## Planet Fitness JSP 18-57

Consideration at the request of PF Michigan Group, LLC for JSP 18-57 Planet Fitness for Planning Commission’s approval of Preliminary Site Plan and Storm Water Management plan. The applicant is proposing a single floor 21,054 square foot indoor recreational facility; popularly known as Planet Fitness. The facility is estimating to serve up top 1000 memberships.

## PLANNING REVIEW

# PLAN REVIEW CENTER REPORT

SCHEMATIC ELEVATIONS

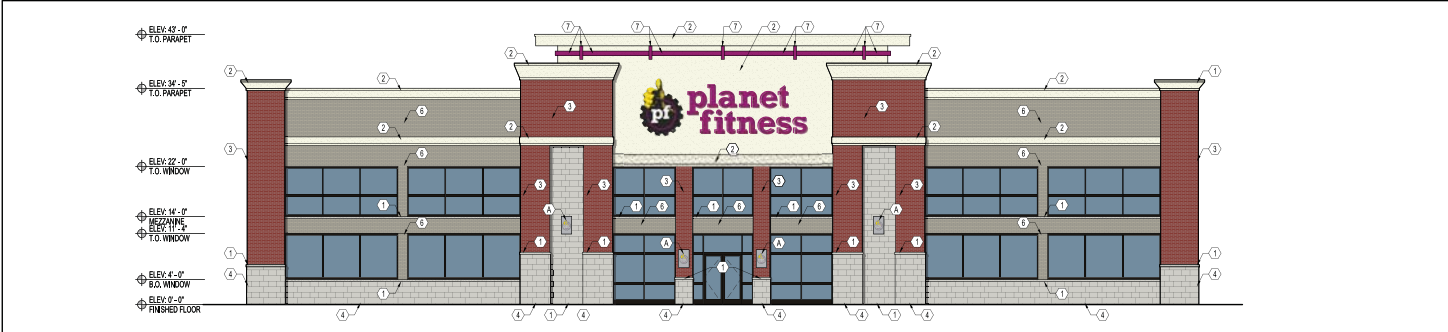
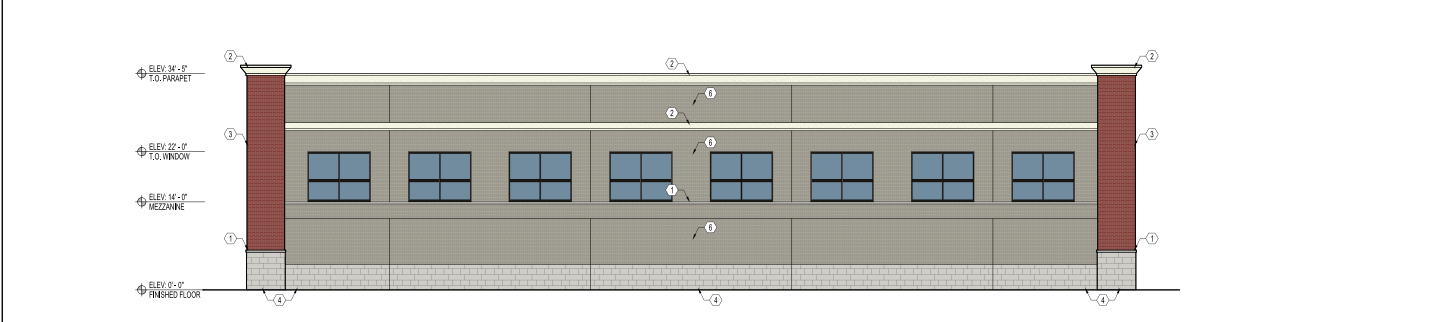
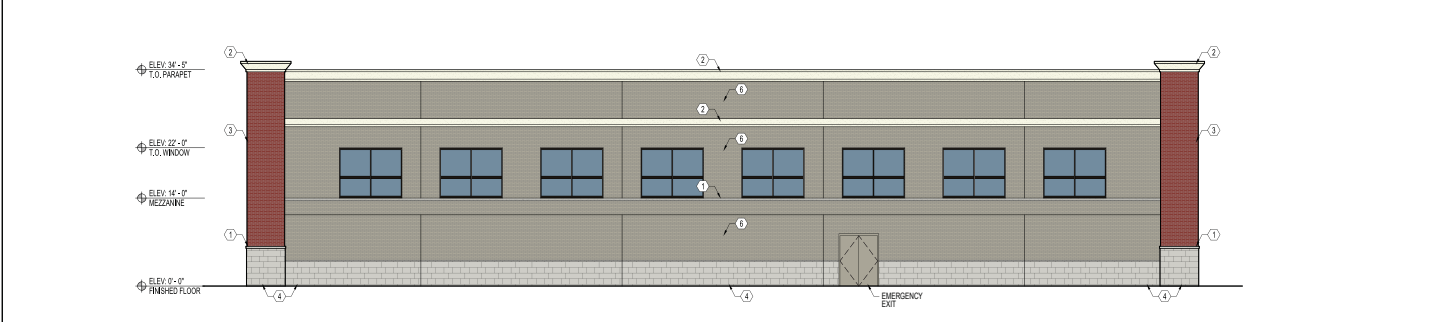
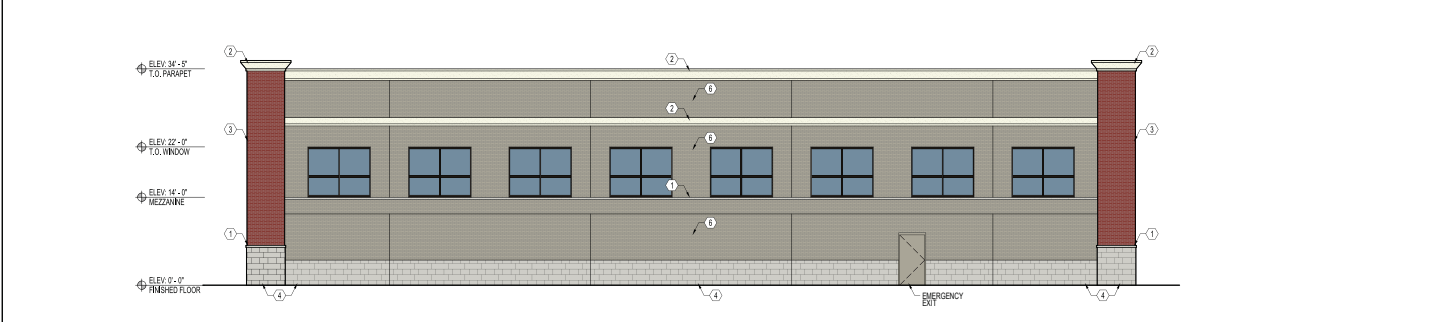
5. Façade Review: The applicant should clarify the size format of item No. 4; Stone in the sample board. In order to qualify as "Stone" this material would have to be 16" high X 24" wide format (the elevations appear to indicate 8" H x 16" W). Please refer to façade review for more details.

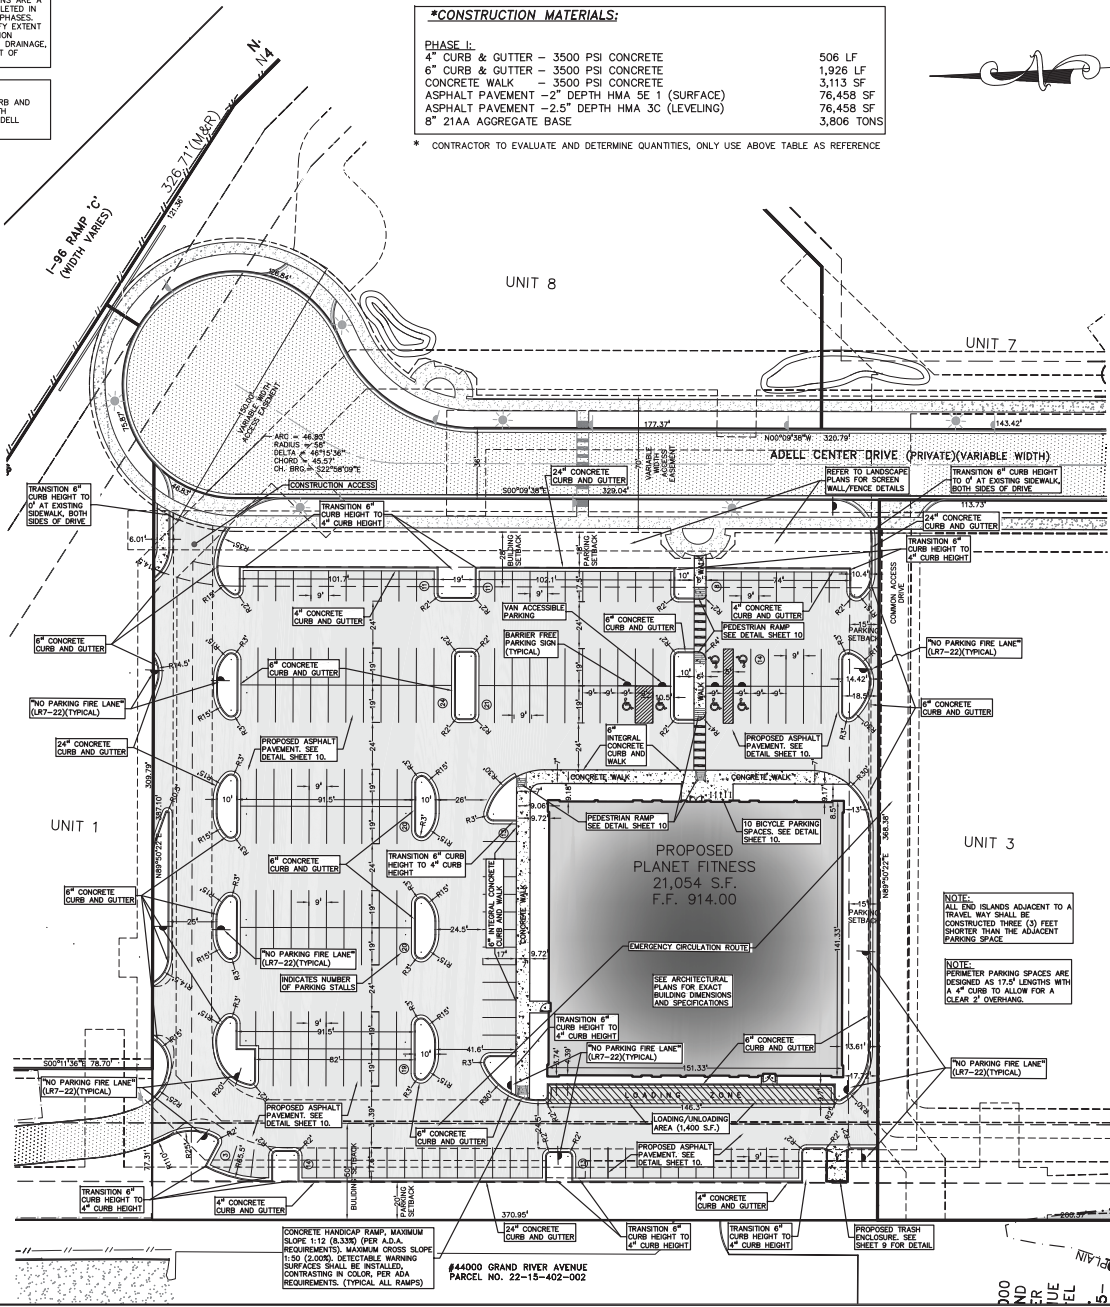
- c. The van accessible space should have a R7-8 sign with a R7-8p (Van Accessible) sign under it instead of the modified R7-8 sign called for on sheet 4 and shown on sheet 10.

- d. The applicant should label all of the "No Parking Fire Lane" signs on sheet 4.
2. The applicant should indicate the proposed signing on site and provide notes and details related to the proposed signing.

7. The applicant shall remove the reference to painted islands on General Note 5 on sheet 4 as there are no painted islands proposed.

7. Brick wall will be provided as required.
8. See attached revised “Site Plan” sheet 4 and additional “Circulation Plan” sheet 11 for reference on firetruck accessibility. Radii have been increased to 30’ in fire truck lanes with the exception of the one end island on the north that abuts the secondary emergency access drive. At this point, the isle width is 26’ and secondary emergency access drive is greater than 30’ width providing an abundance of area for maneuverability. There is still a 30’ inside swing radius as shown on the “Circulation Plan”.

- See attached revised “Site Plan” sheet 4 and additional “Circulation Plan” sheet 11 for reference on firetruck accessibility. Radii have been increased to 30’ in fire truck lanes with the exception of the one end island on the north that abuts the secondary emergency access drive (to the north). At this point, the isle width is 26’ and secondary emergency access drive is greater than 30’ width providing an abundance of area for maneuverability. There is still a 30’ inside swing radius as shown on the “Circulation Plan”.
